GRADING & EROSION CONTROL PLAN

FOR TOWNHOMES AT WESTERN

LOT 1, CIMARRON SOUTHEAST FILING NO. 2C, SOUTHEAST QUARTER SECTION 7, TOWNSHIP 14 SOUTH, RANGE 66 WEST OF THE 6TH P. M., EL PASO COUNTY, COLORADO

PCD FILE # **PPR2415**

GRADING & EROSION CONTROL PLAN
EROSION CONTROL
C1.6 MVE PROJECT 61203
MVE DRAWING GEC-EC
MARCH 21, 2024
SHEET 6 OF 8

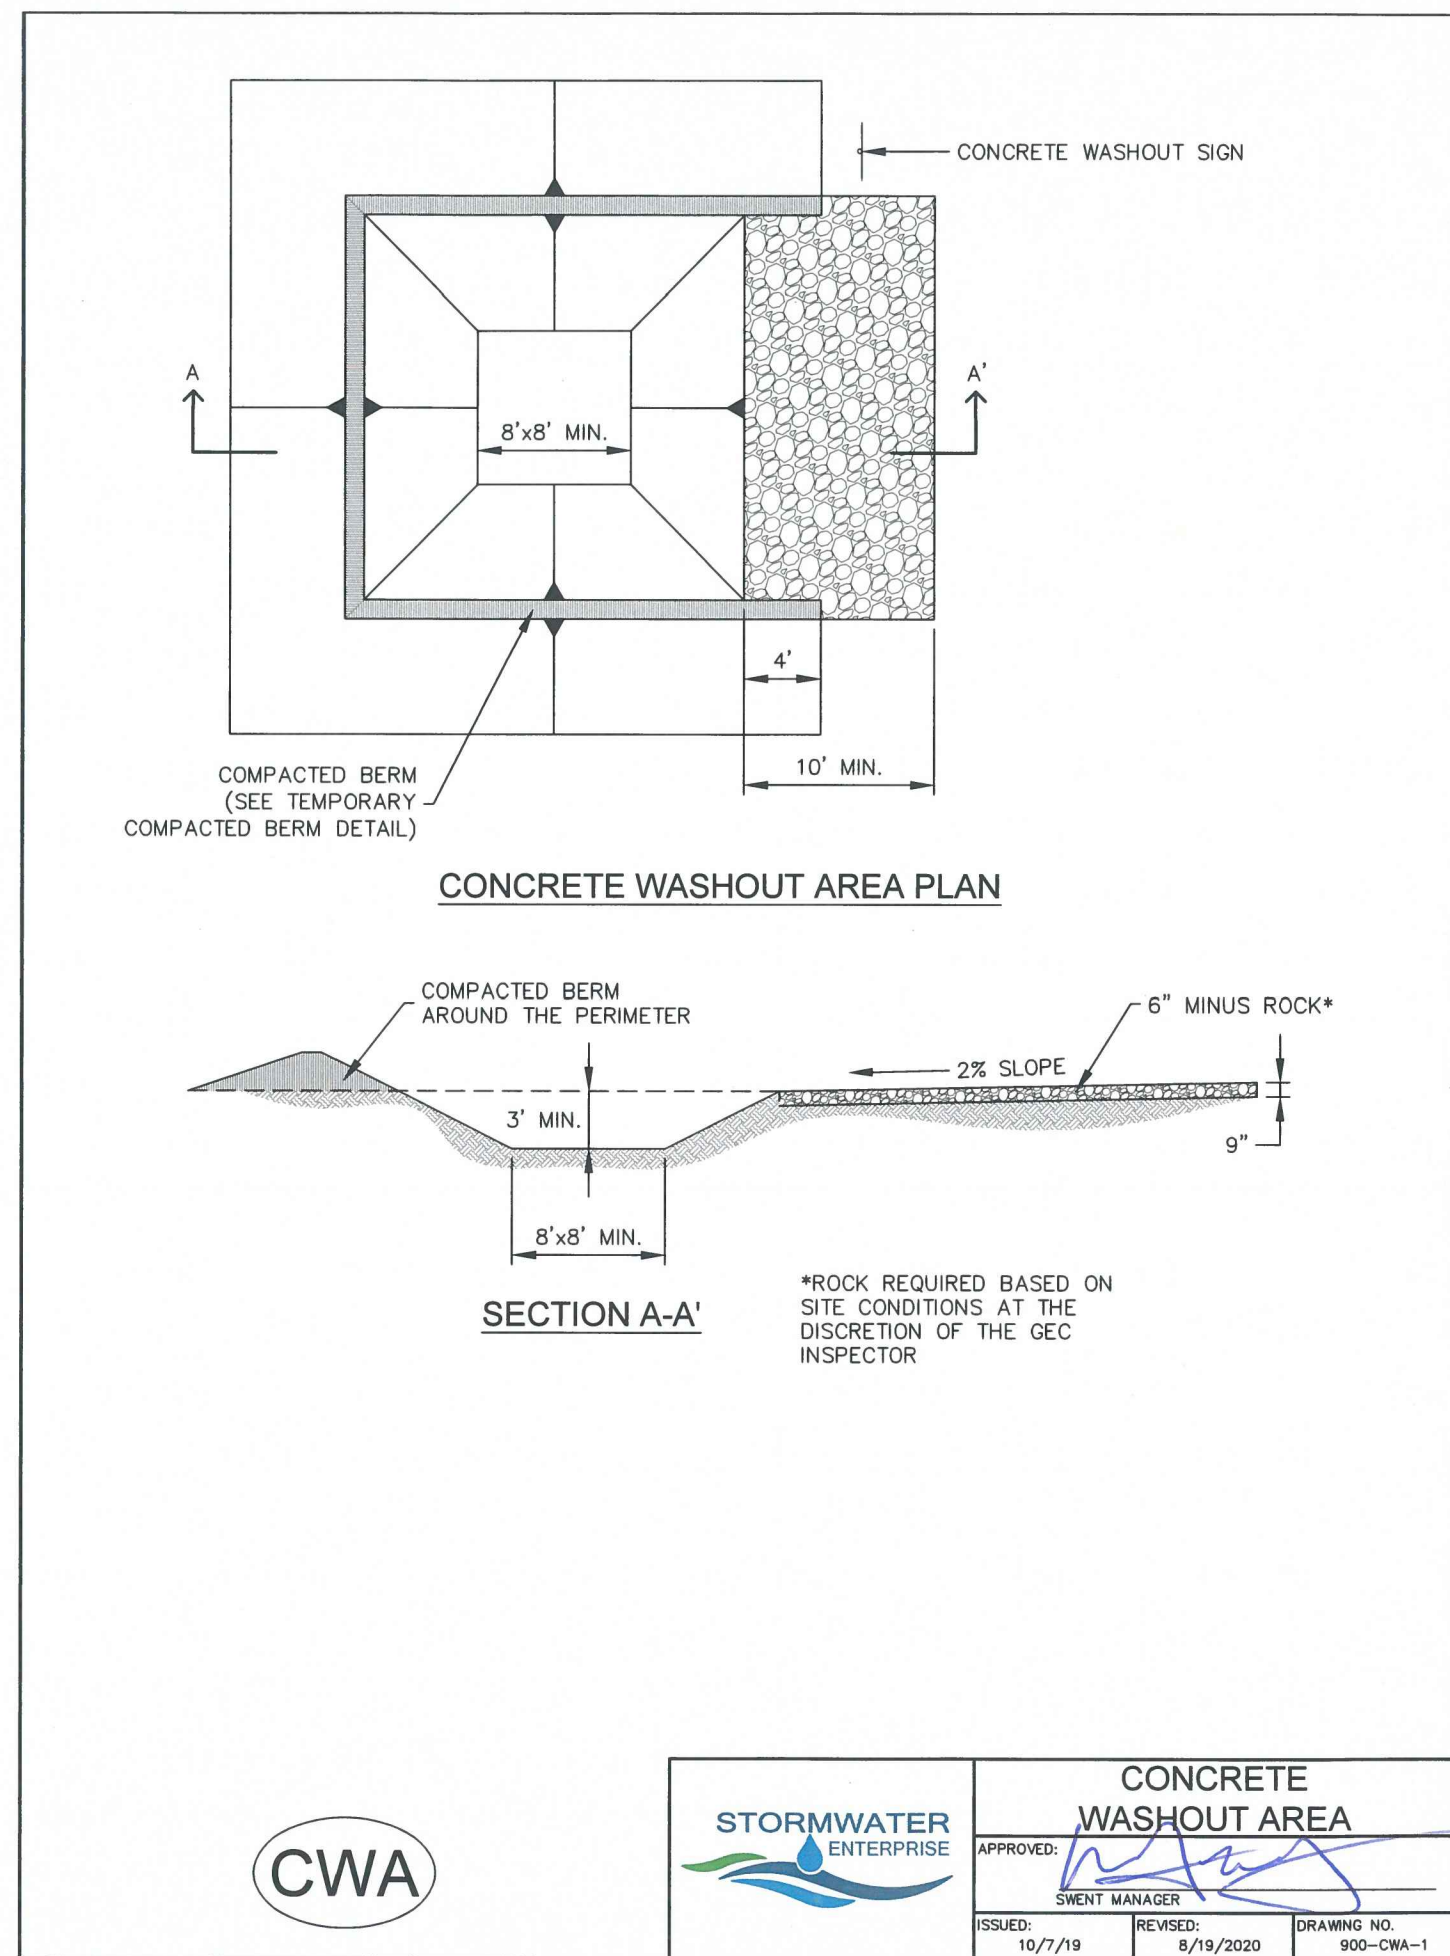
turn on major contour labels

SCL or SF? Bubble does not correspond to adjacent text. FAE shows quantity of 0 for both..

add: "and ECB."

C1.8

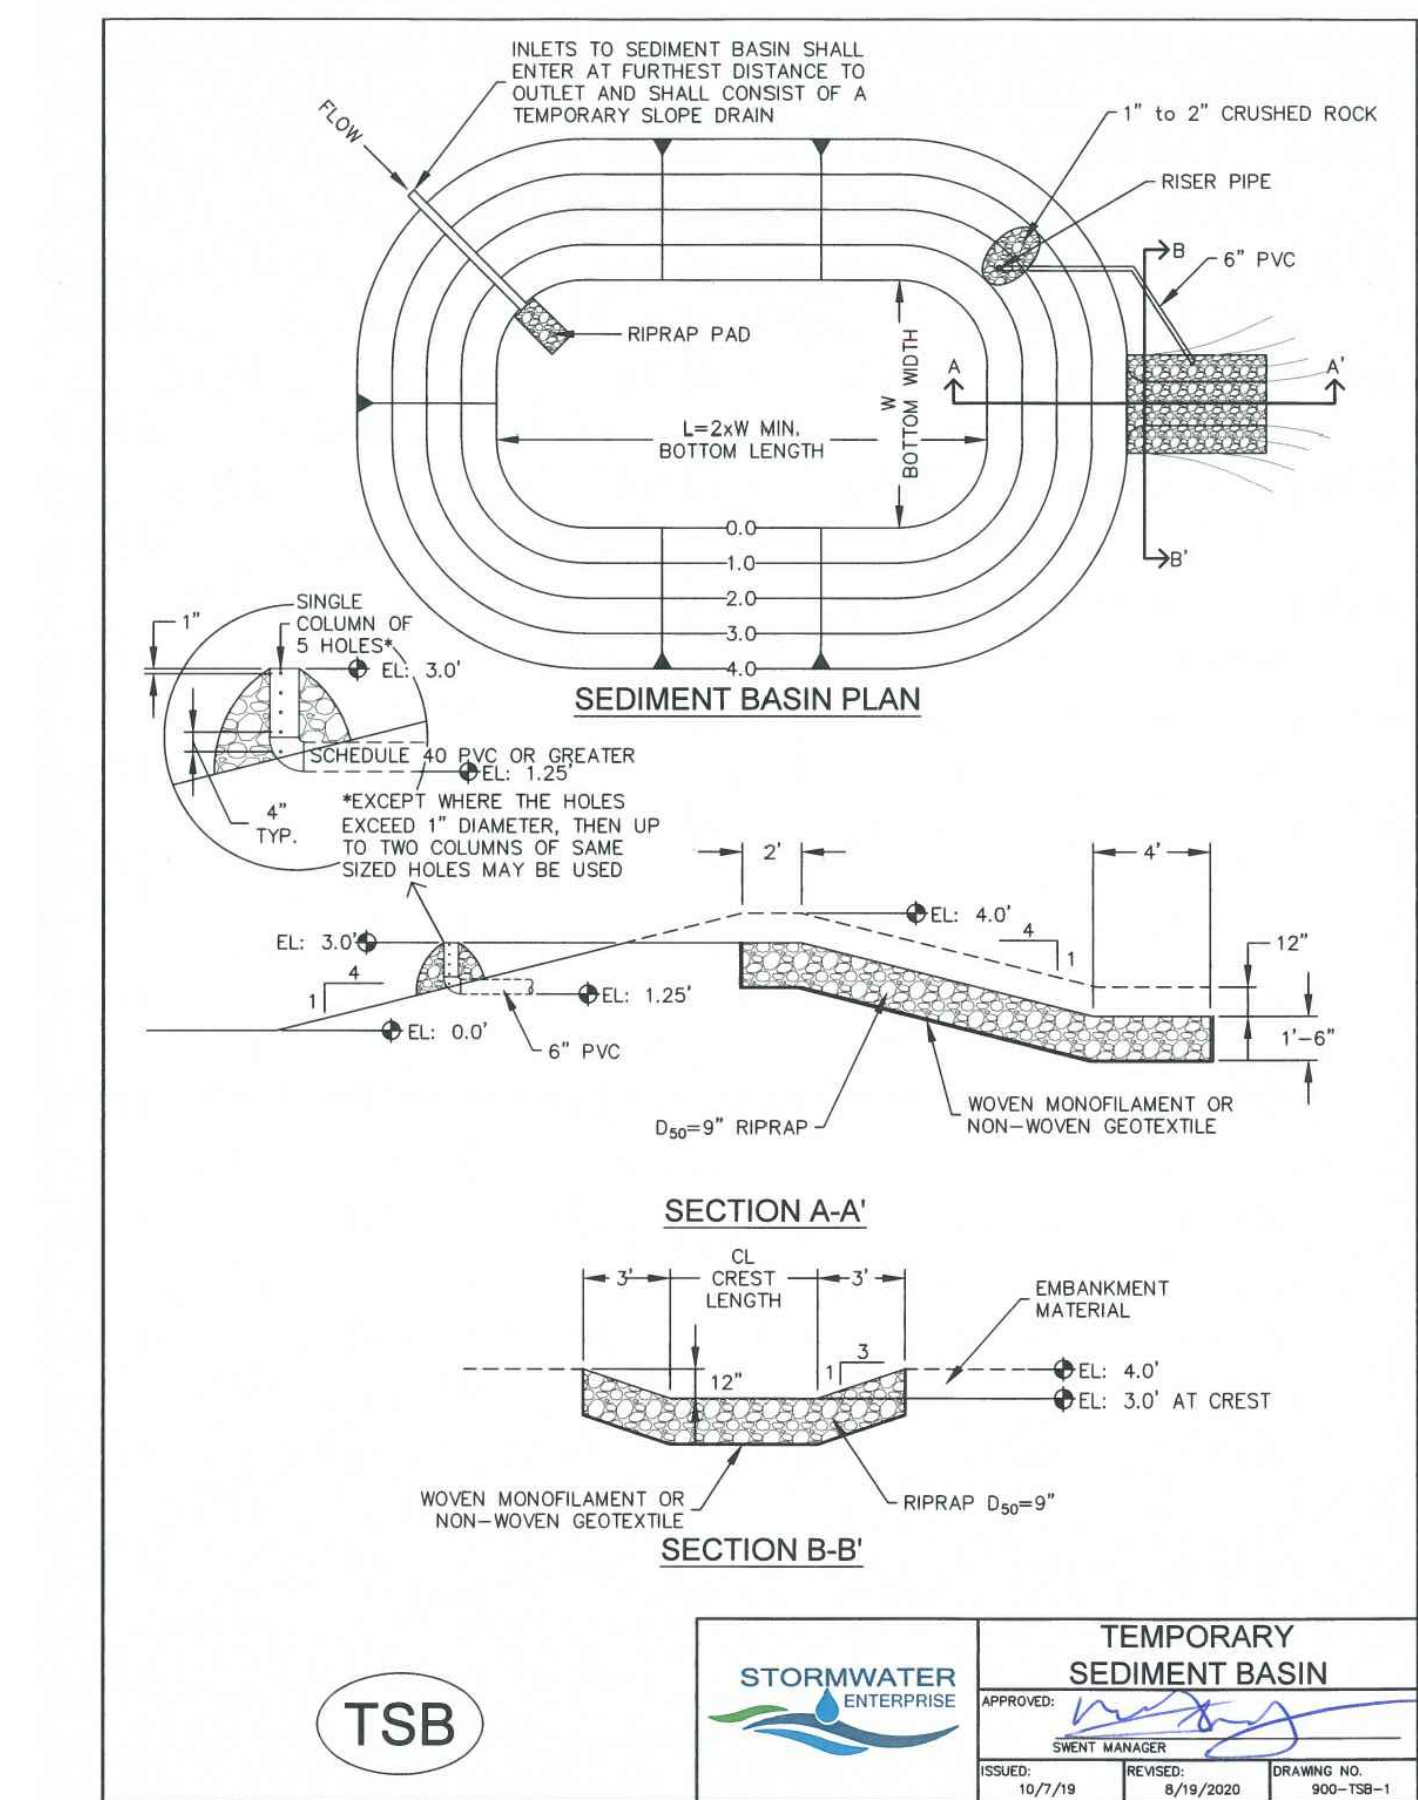
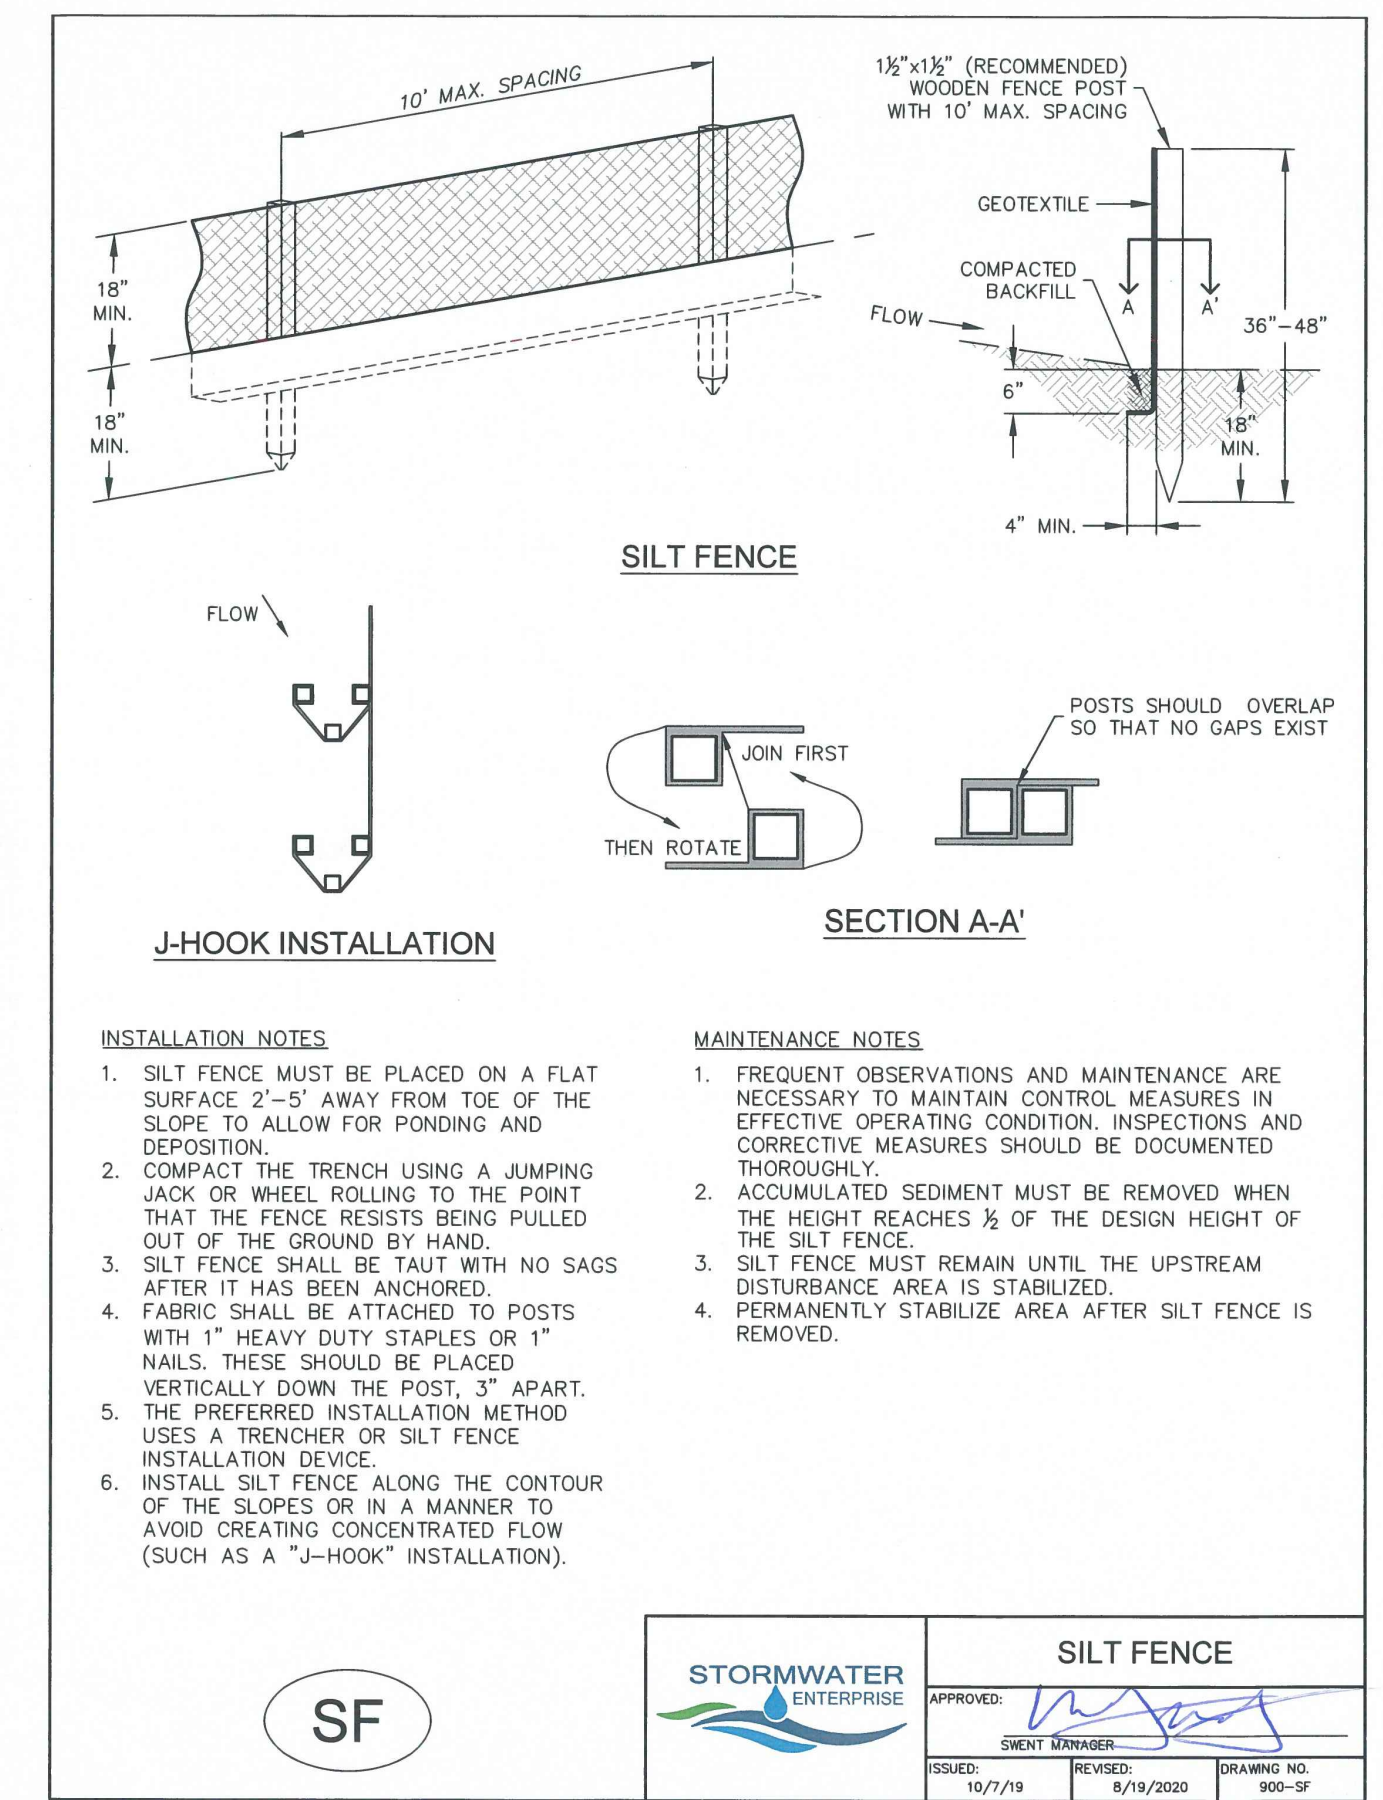
GEC Checklist Item Z. Include details for the following BMPs. Examples of acceptable details for each are provided:

BMP	Detail # and Source		
	DCM (Vol 2; Chap 3.3)	MHFD (USDCM Vol 3; Chap 7)	COS - Stormwater Construction Manual (App E)
Construction Fence		SM-3	
Rolled Erosion Control Products	ECB-1, ECB-2	EC-6	X
